**2318ADDSN - Addendum No. 1  
To Plans, Contract Documents and Specifications**

**Addison Municipal Airport (ADS)  
Taxiway B Extension – Phase I  
TxDOT CSJ No. 2318ADDSN**

#### PSET-SC

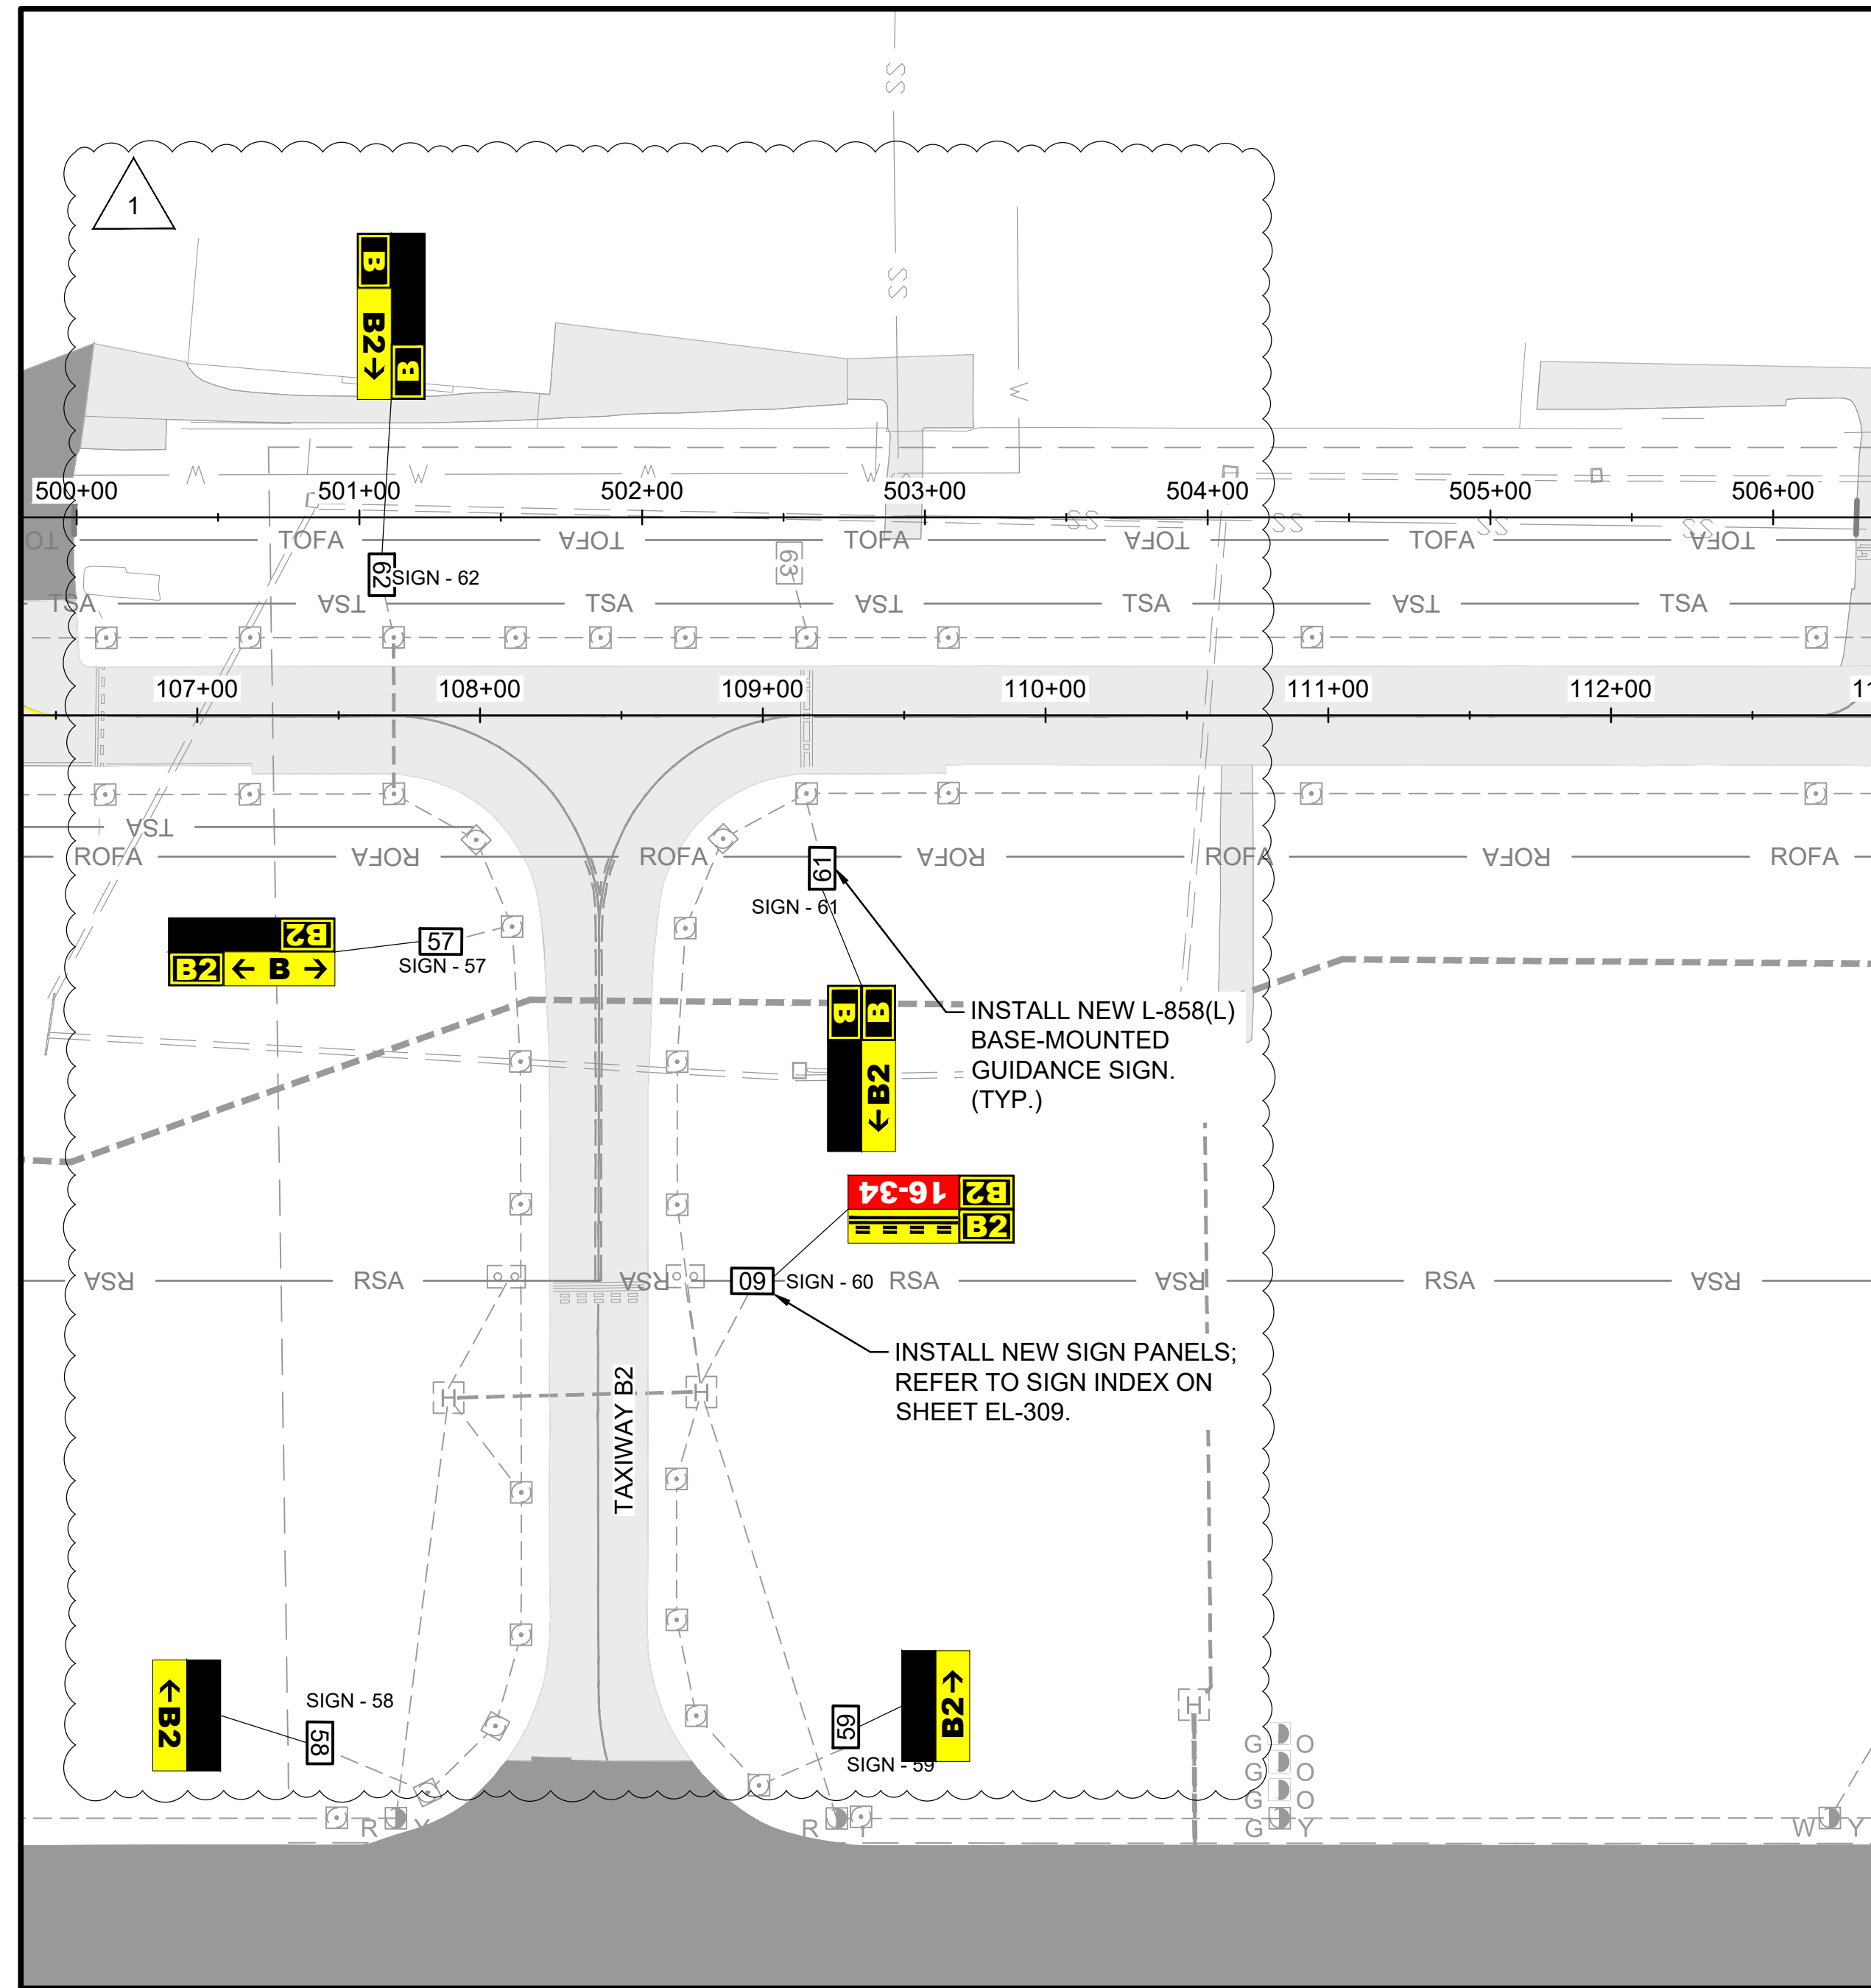
Sheet CC-504: The scale of the TxDOT detail was adjusted to properly fit the page.

- e) Sheets 38 – 40 did not plot correctly, can you reissue these?
  - Yes, these sheets will be corrected and reissued in Addendum No. 1.
- f) The hatch pattern for the Concrete Encased Pipe detail on plan sheet 162 is for CTB. The note says 6" Lime treated subgrade. Can you confirm which is required?

LIGHTING  
 INSTALLATION PLAN 1

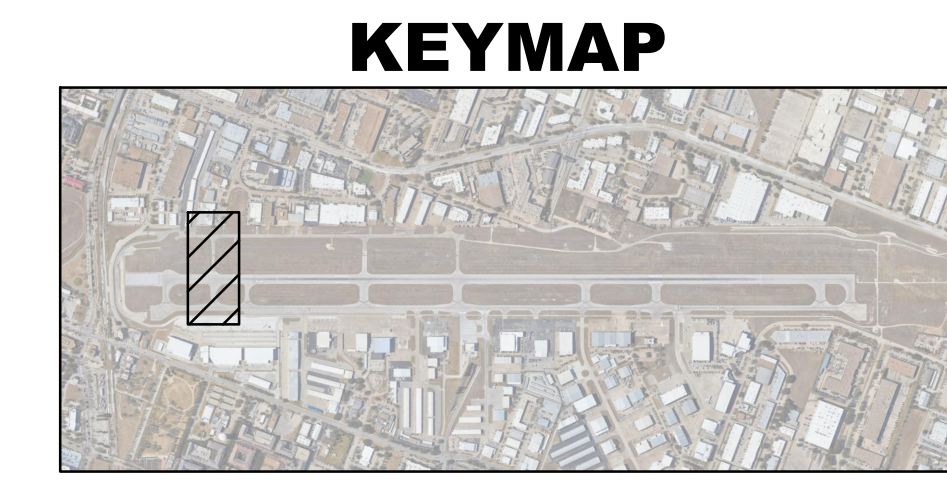
Sheet EL-101: Sign legends were corrected to match the sign index.

**1 CONCRETE ENCASED PIPE BEDDING DETAIL**  
 SCALE: NONE

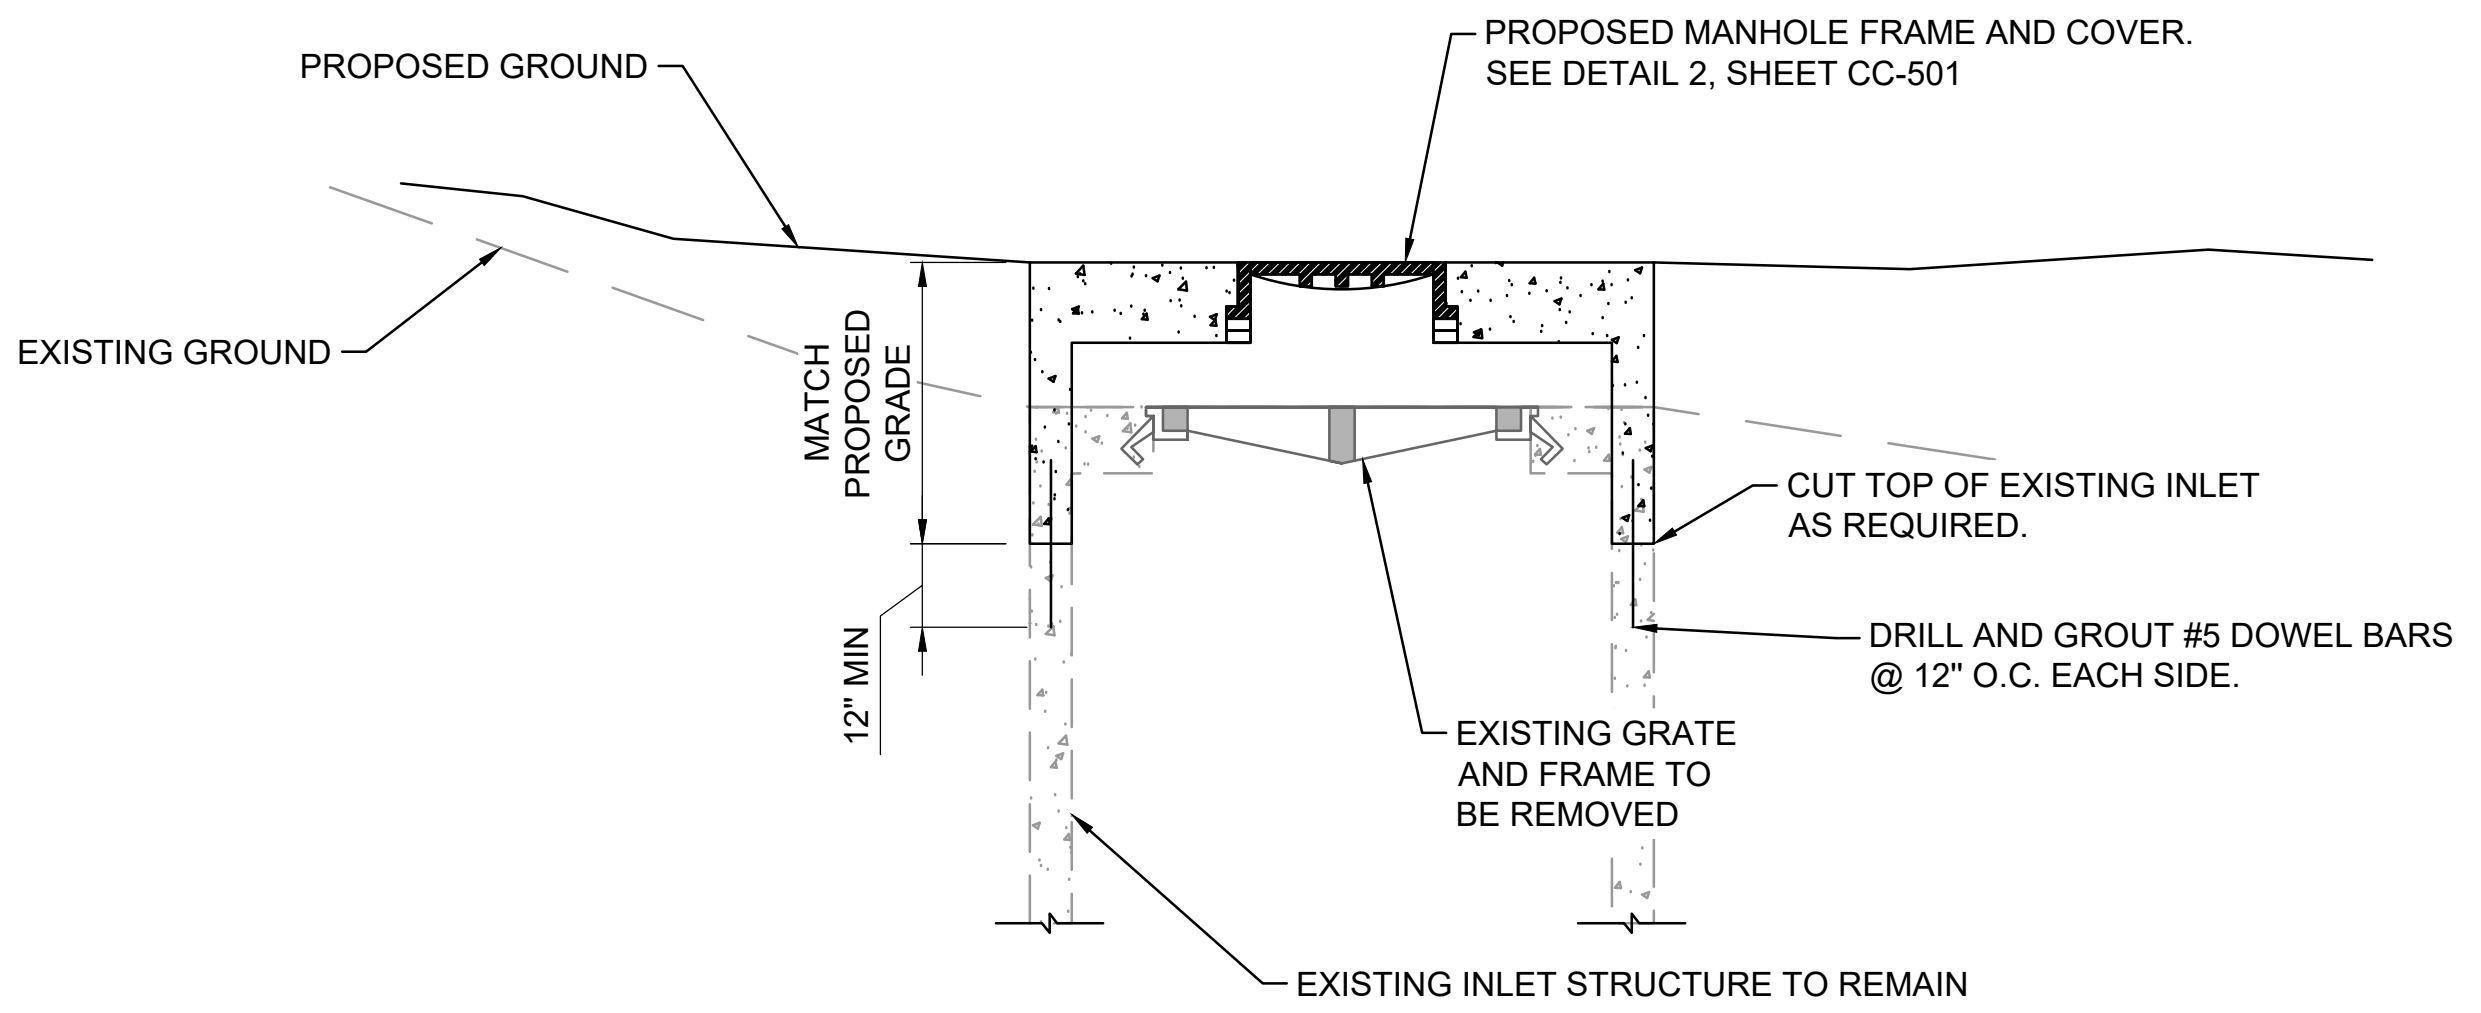
Sheet CC-501-2: The hatch patterns of Detail 1 were corrected to accurately reflect the called-out materials.

- The note was correct, the hatch patterns have been updated, and the updated sheet will be included in Addendum No. 1.
- g) Additive Alternate 2, Sheet 168, shows the joint layout for the VSR. Except for the tie-ins, there is no reinforcement in this item. The bid item is for TxDot Item 360. Is it the intent to use item 360 for the payment and the joint layout for the reinforcement?
